**Avnet MicroZed 7020**  
**Revision G Errata**  
**V1.1**  
**02 March 2019**

#### 3.1 PUDC\_B Pull-up Populated with 0-ohm instead of 1K-ohm

Figure 2 – JT4 Pull-up Connected to PUDC\_B, JX1\_LVDS\_2\_P, and JX1-Pin17

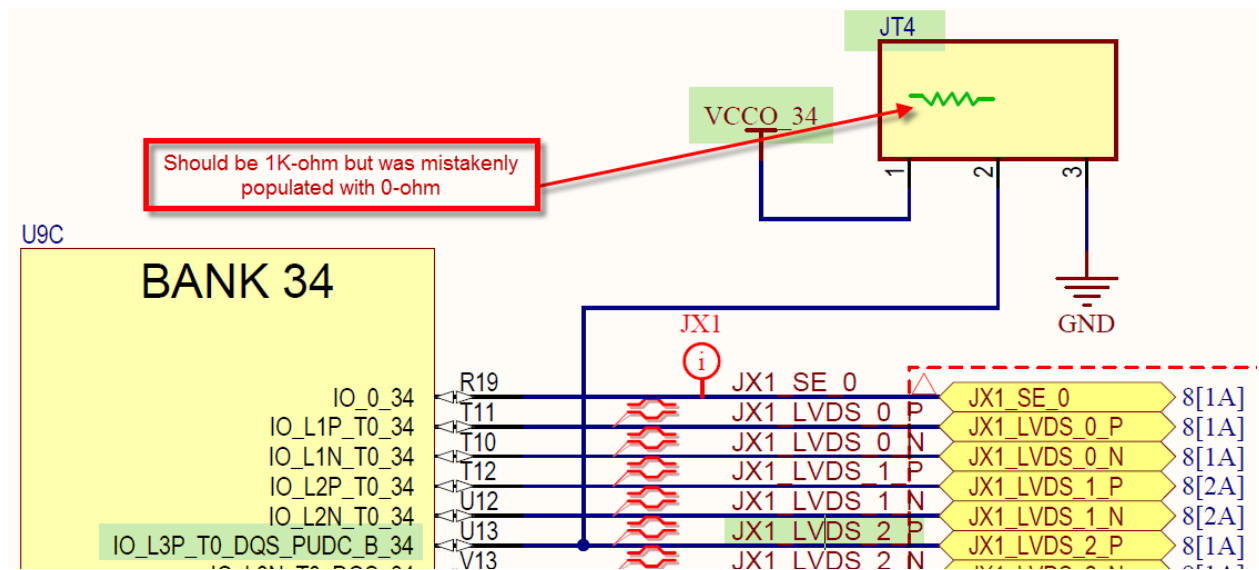
On MicroZed, the PUDC\_B signal is in Bank 34 of the Zynq-7000, Pin U13 on component U9C on Sheet 6 of the schematic document. This pin is tied to schematic signal JX1\_LVDS\_2\_P, which is also tied to resistor jumper JT4 and MicroHeader JX1 Pin 17.

Resistor jumper JT4 is a 3-pad component that allows an 0402 resistor to be placed either in the 1-2 position or the 2-3 position. By default, this was supposed to be populated with a 1K-ohm resistor in the 1-2 position. Unfortunately this was mistakenly populated with a 0-ohm resistor, thus shorting JX1\_LVDS\_2\_P to power supply VCCO\_34. This effectively disables PUDC, but it also makes this I/O unusable.

**Figure 3 – JT4 on MicroZed**

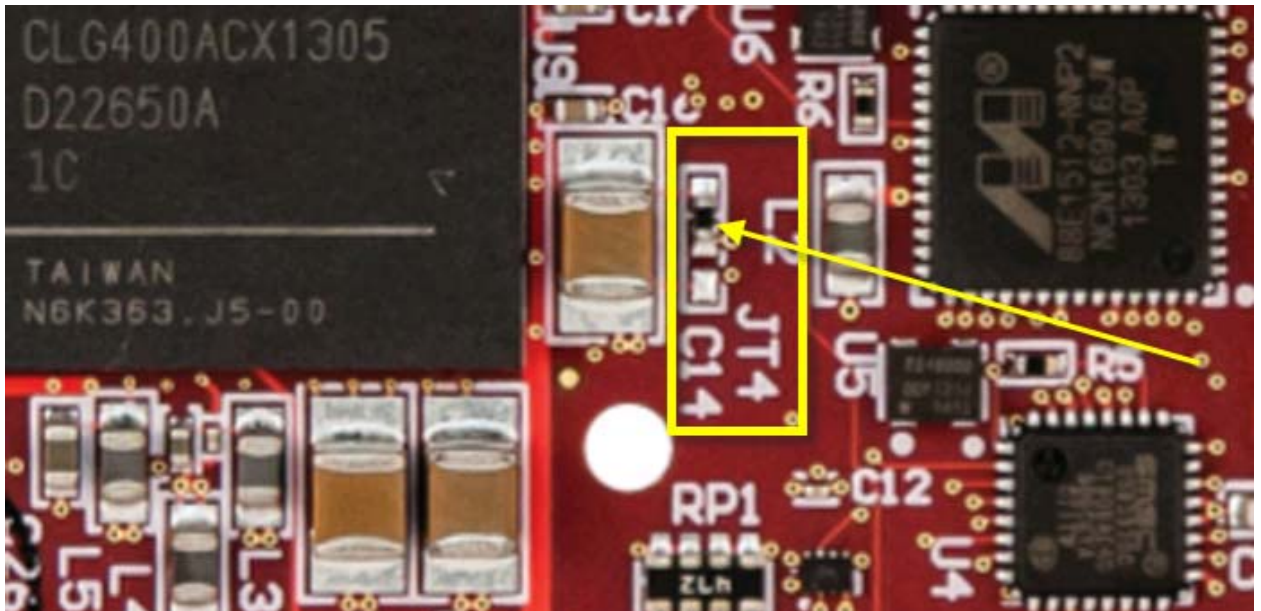
1. Remove the resistor at position 1-2 of JT4.

2. Solder a new, 0402 1K-ohm resistor to position 1-2 of JT4. A few suggestions are listed below.
  - a. Panasonic Electronic Components ERJ-2RKF1001X
  - b. Yageo AC0402FR-071KL
  - c. Yageo RC0402FR-071KL

Figure 4 – Repaired MicroZed Rev G Board

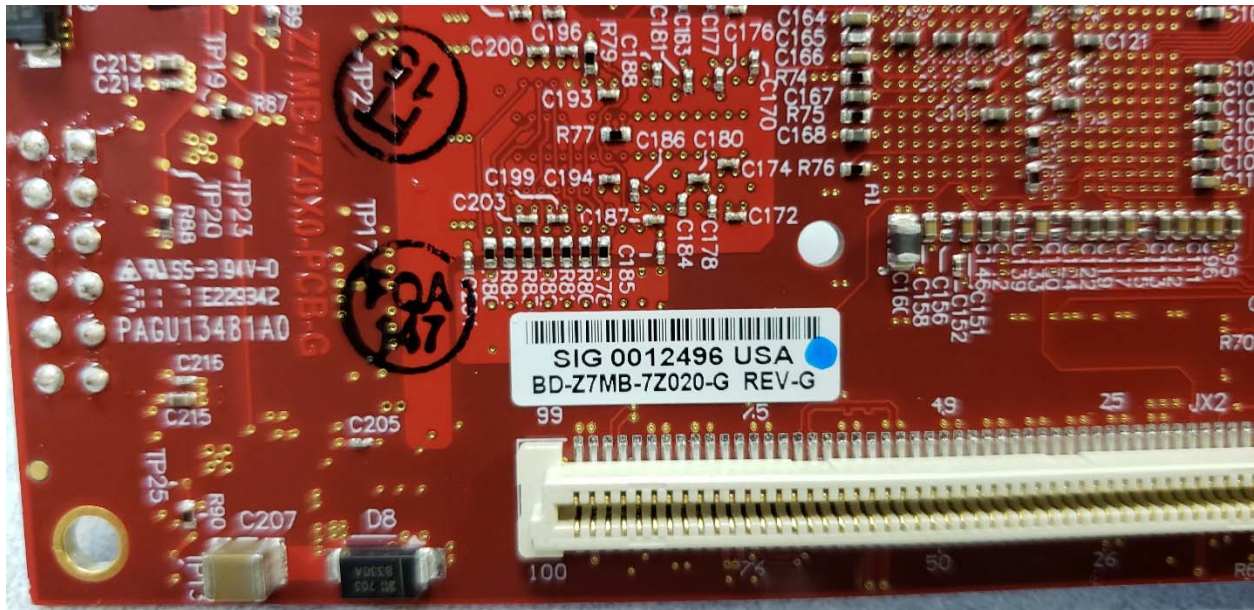
A repaired Revision G board that has this workaround in place will be identified with a blue mark on the bar code label as shown below:
